**COMMUNITY DEVELOPMENT DEPARTMENT
PLANNING DIVISION
STAFF REPORT**

TO: Design Review Board
FROM: Planning Staff – Jeremy Hammar, Senior Planner
DATE: January 23, 2025

RE: Gig Harbor Fire & Medic One, Station 51 (PL-DR-24-0017)
Public Meeting Date: January 23, 2025

SITE PLAN

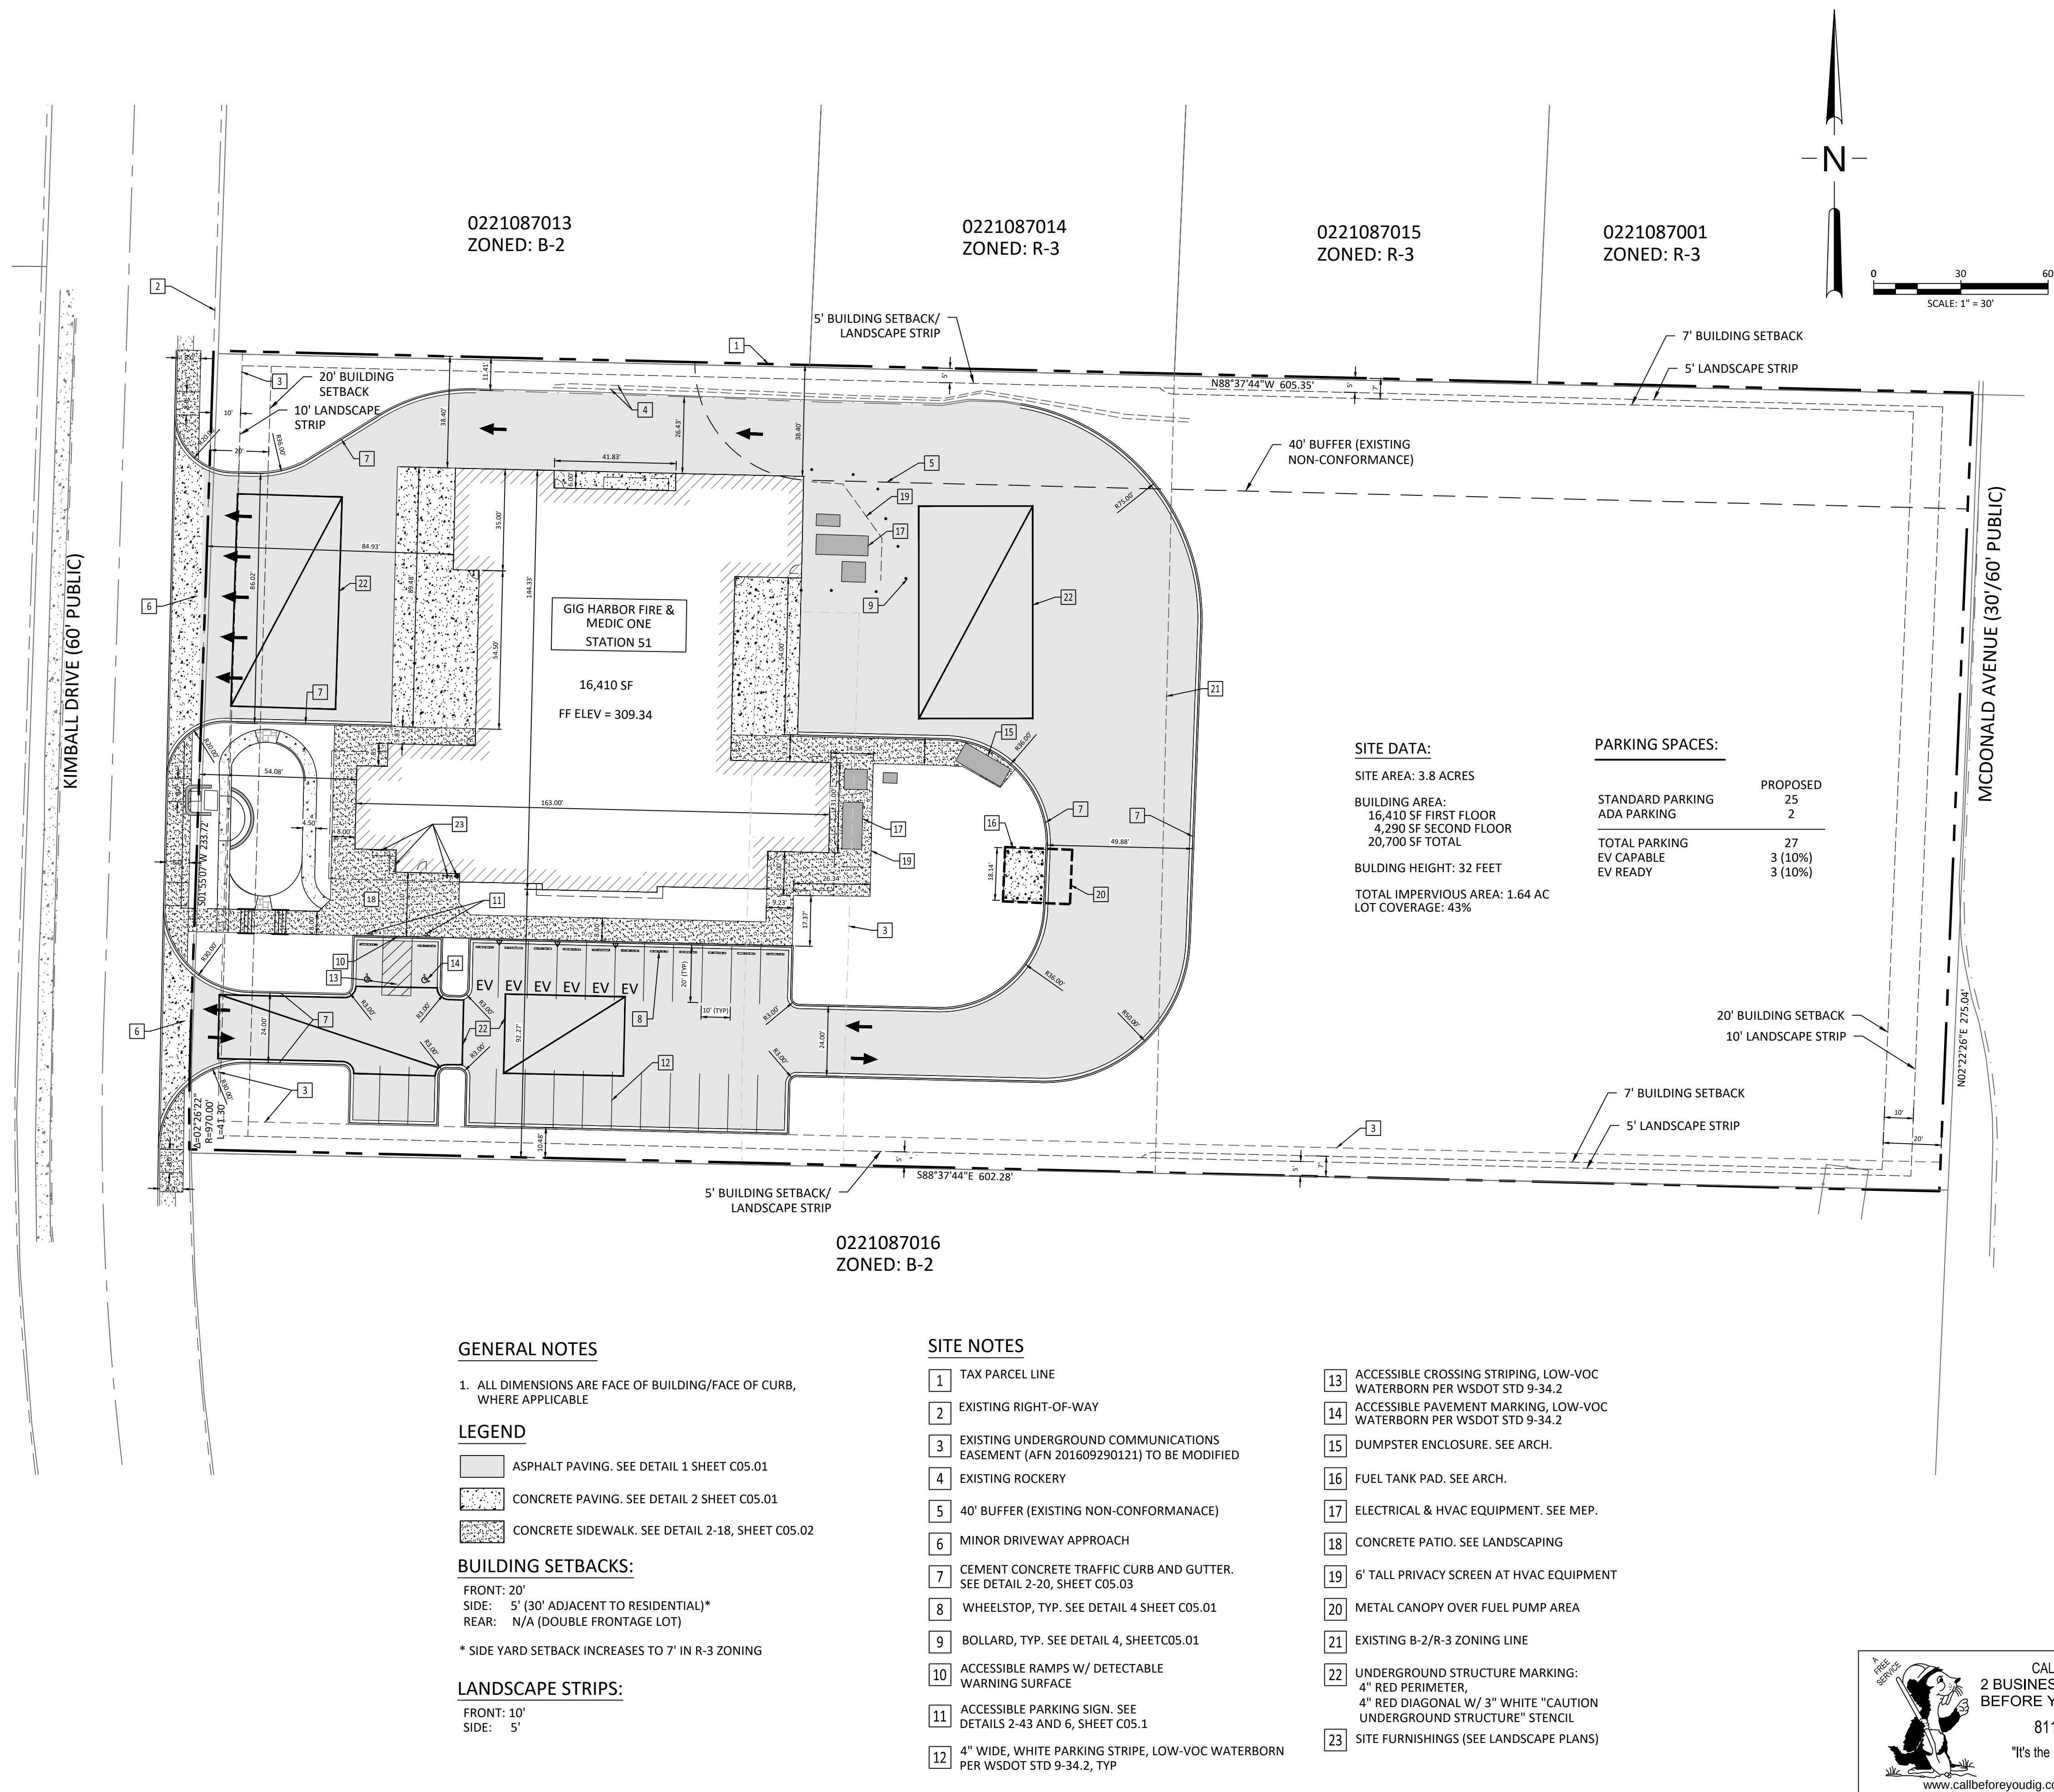
1. **GHMC 17.99.300(B) Nonresidential Setbacks– Locate structures new front setback line**: At least 50 percent of the primary structure's front façade shall be places on the front setback line (except in the historic district or unless retention of significant tree(s) warrants an increased setback). Additional structures on the

Staff Analysis: In this instance, special conditions and circumstances exist which render GHMC 17.99.300(A) unnecessary as applied to development on the site. There is more than 5 feet of vertical separation from the finished floor elevation of the existing fire station to Kimball Drive. As the front yard setback is 20 feet wide, meeting this standard would require significant earthwork, retaining walls and potential utility conflicts. The existing structure as well as structures on adjacent parcels are set back from the front property line in a similar manner. Additionally, given the existing and proposed use of the site, emergency service vehicles must have the ability to fully clear the apparatus bay before entering the right of way.

Staff Analysis: With the operational use as a fire station, emergency service vehicles must be able to fully clear the apparatus bay before entering the right-of-way. The station is designed to accommodate fire equipment with an overall length of roughly 60 feet.

Staff Analysis: Public open space is being provided in the front yard of the station between the primary access driveway and the apparatus driveway. These elements of the site plan, in addition to the site's holistic design, sufficiently support the requested design exception.

SITE PLAN

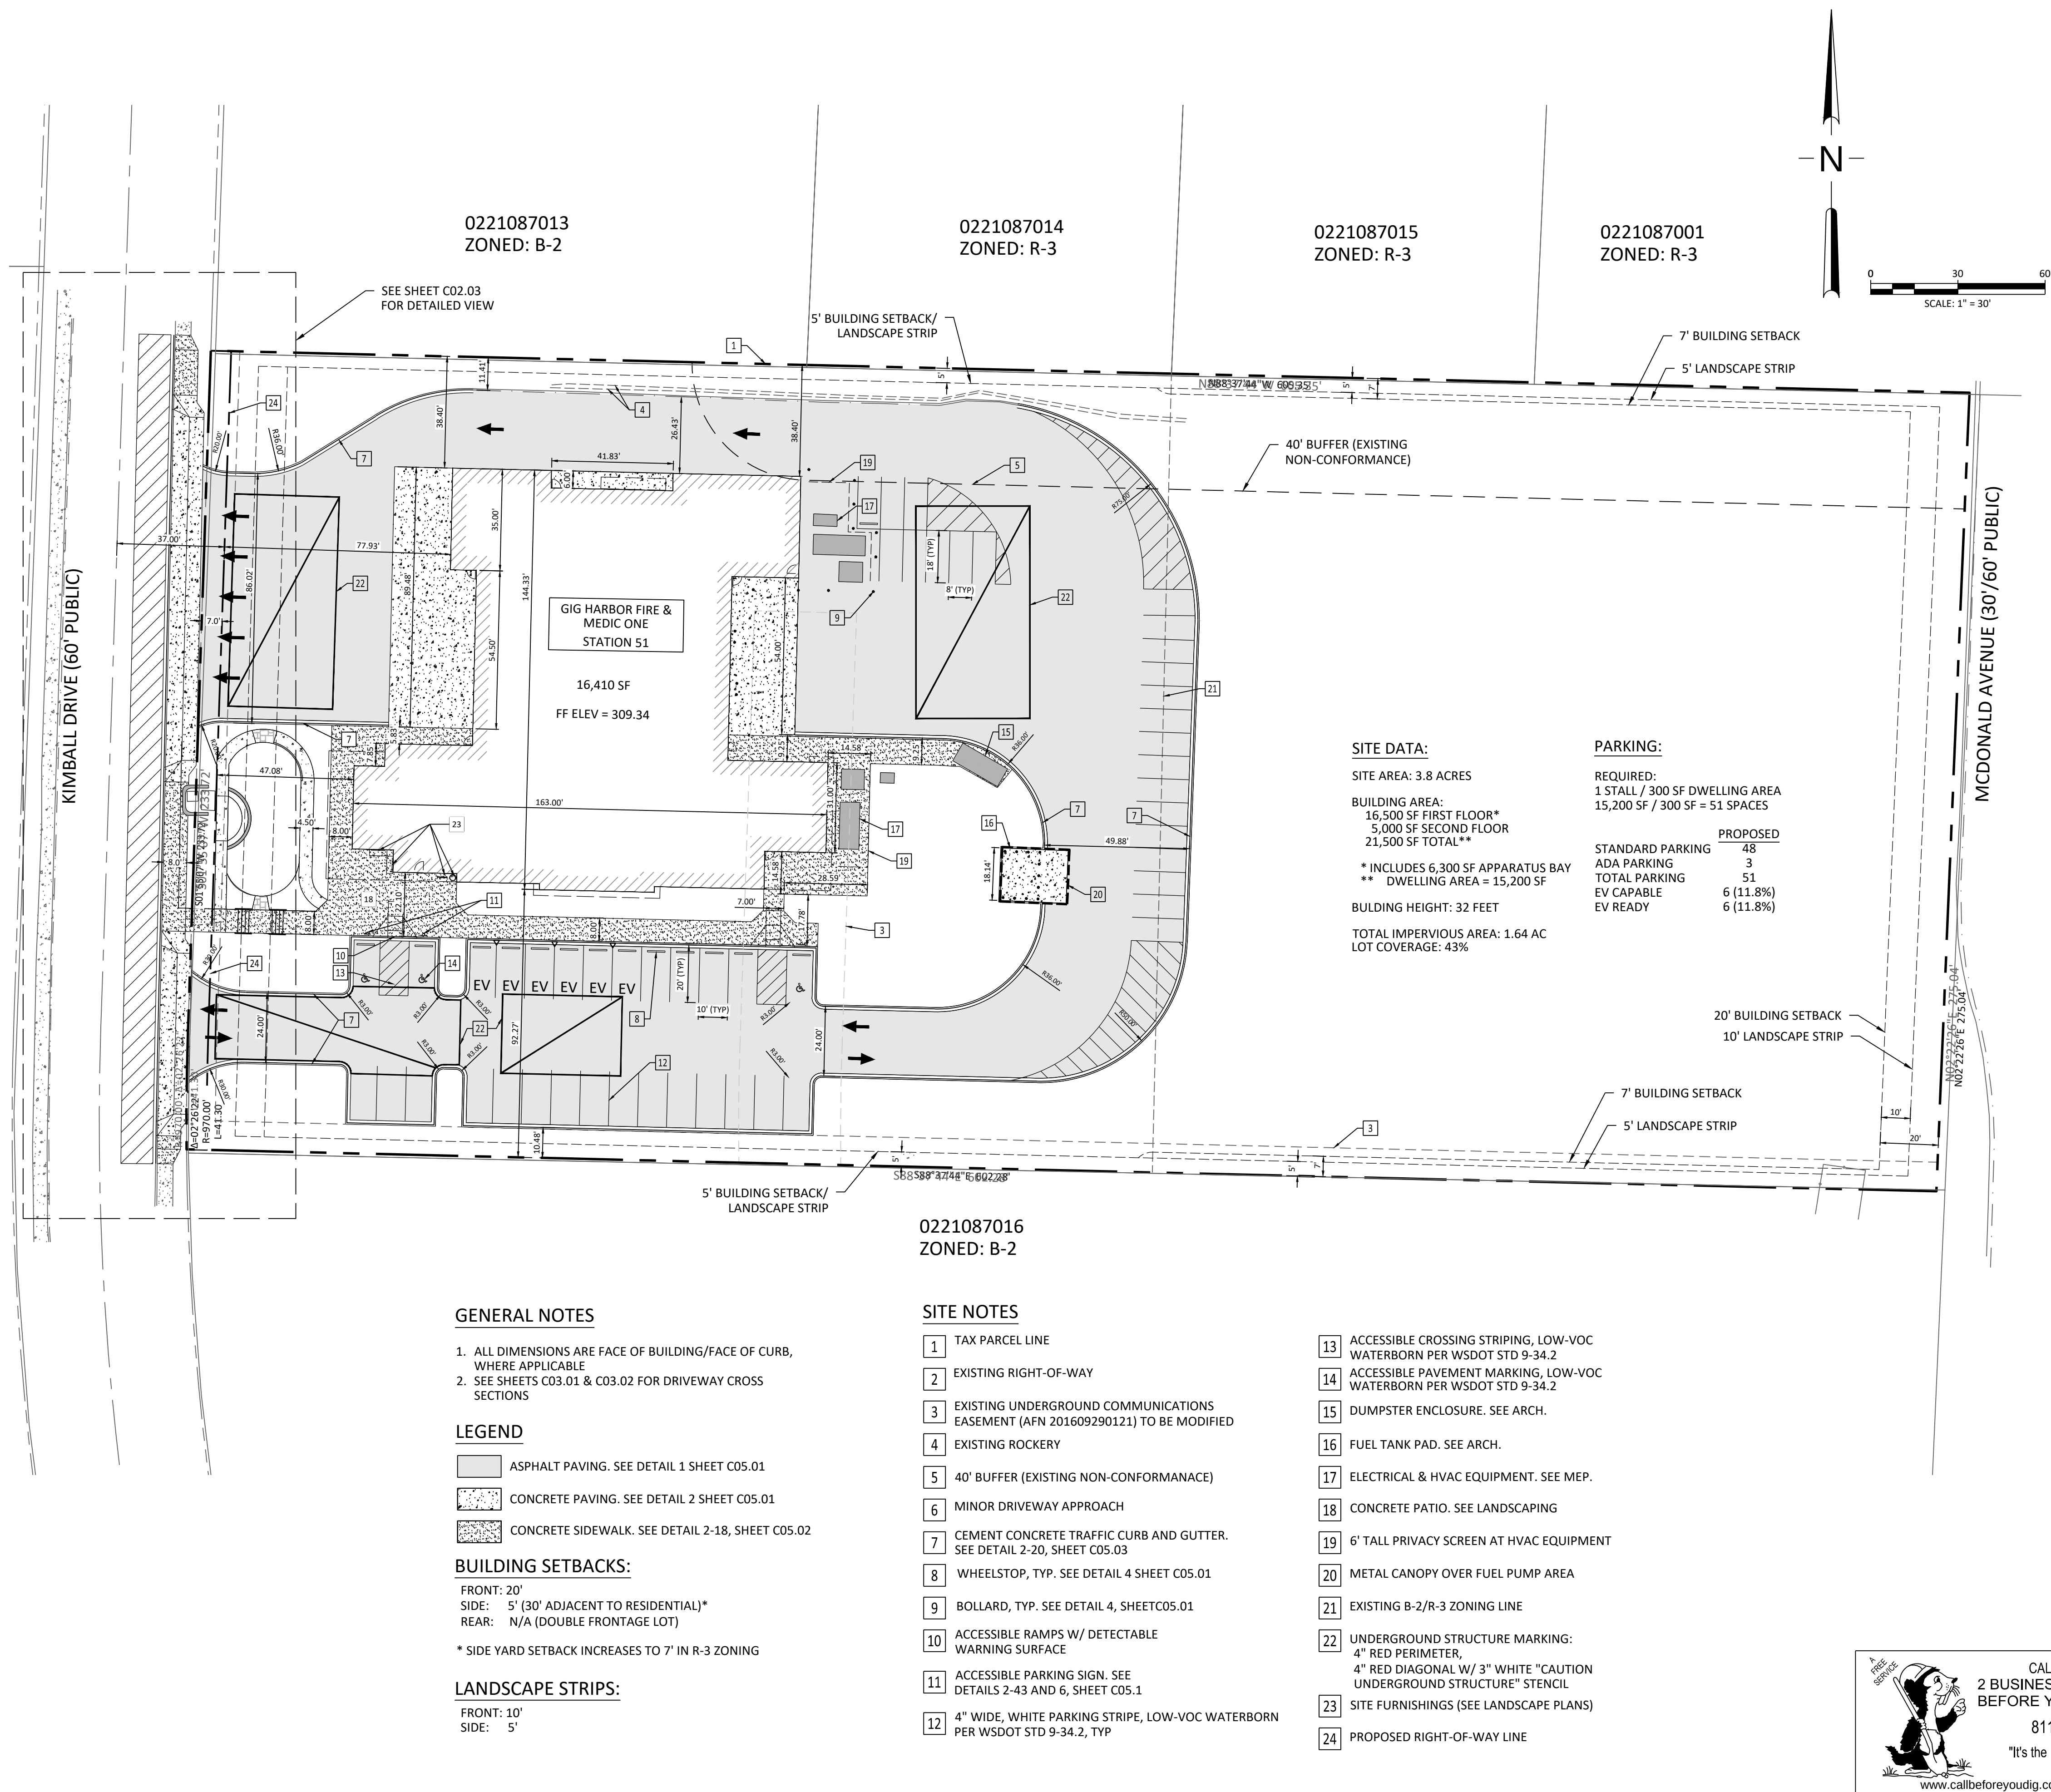
2. **GHMC 17.99.330 – Parking Lot Standards:** GHMC 17.99.330(A) To Maximize landscaping at the street face, curb cuts for driveways shall be limited to one cut per parcel frontage or one cut per 200 feet of parcel frontage, subject to public works

Staff Analysis: In this instance, special conditions and circumstances exist which render GHMC 17.99.330.(B) unnecessary as applied to development on the site. For the site to function properly, multiple vehicles must be able to exit the site unimpeded from potential traffic conflicts. The proposed extra-wide driveway will be aligned with the apparatus bay doors allowing multiple vehicles to exit the station and turn onto Kimball Drive without the need for internal site maneuvering.

Staff Analysis: The extra-wide driveway for emergency vehicle use is typical of modern fire station design.

Staff Analysis: The proposed design helps to preserve trees at the eastern half of the parcel. Additionally, public open space is being provided at the front portion of the property between the primary access driveway and the apparatus driveway.

GHMC 17.99.330.A allows for one driveway per 200 feet of frontage. The site has 275 feet of frontage; therefore, two driveways are permissible. A primary driveway near the southern portion of the frontage will provide full access for staff, visitors, and returning emergency vehicles.
